SUBJECT: SAFETY EVALUATION REVIEW OF THE SOG/EPRI TOPICAL REPORT TITLED  
"SEISMIC HAZARD METHODOLOGY FOR THE CENTRAL AND EASTERN UNITED  
STATES", EPRI NP 4726

Subject: Safety Evaluation Review: SOG Topical Report,  
"Seismic Hazard Methodology for the Central and  
Eastern United States."

Aided by its consultant, the U.S. Geological Survey (USGS), the Nuclear Regulatory Commission (NRC) reviewed "Seismic Hazard Methodology for the Central and Eastern United States."\* This topical report was submitted jointly by the Seismicity Owners Group (SOG) and the Electric Power Research Institute (EPRI) in July 1986 and was revised in February 1987.

Figure X.A

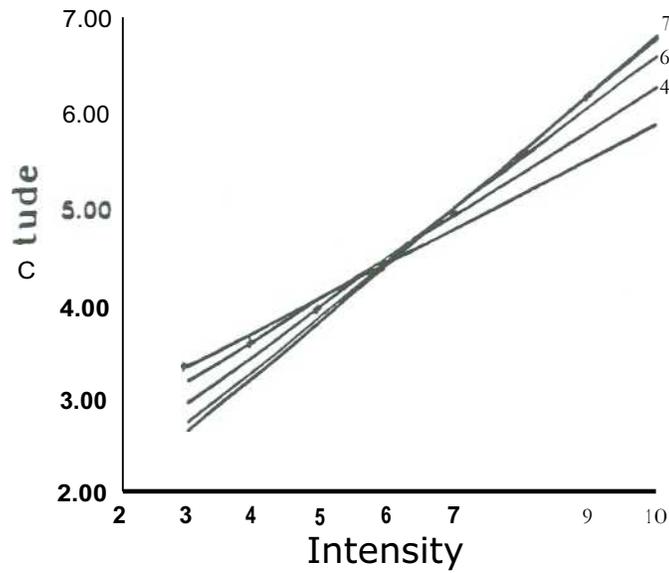
Figure X.A reproduced from Bender (1987) illustrates the different lines  $mb = a + bI_0$  that may result for the same set of earthquakes when different ranges of  $I_0$  values are used to fit the lines. It is assumed the  $I_0$  values contain errors and a fraction of the earthquakes with low intensity values are missing from the data set. Figure X.A illustrates that 'missing' earthquakes affect the values of the fitted coefficients even if the missing earthquakes are outside the range of magnitudes used to fit the coefficients. Similarly, Table X.A. illustrates the range of  $a$  and  $b$  values in the relationship  $mb = a + bI_0$  that may result when intensities in various ranges are used to fit the coefficients. Results shown are for two models in which the maximum magnitude is infinite and one model in which the maximum magnitude is 7.3. A friction of lower magnitude earthquakes is missing in each case, and no earthquakes with magnitude  $mb < 2.7$  have been recorded. The true slope of the line is 0.6, but the fitted slope may be as low as 0.36 if low intensities are used in the fit. The true  $a$  is 1.54, and in the doubly infinite model, the expected value of the fitted  $a = 0.82$ . The correction to obtain  $mb$  is based on the assumption that  $a = 0.82$ . However, we observe that  $a$  may be greater than 2.2, and is never a small 0.82. Thus, the correction may never be applicable to real data.
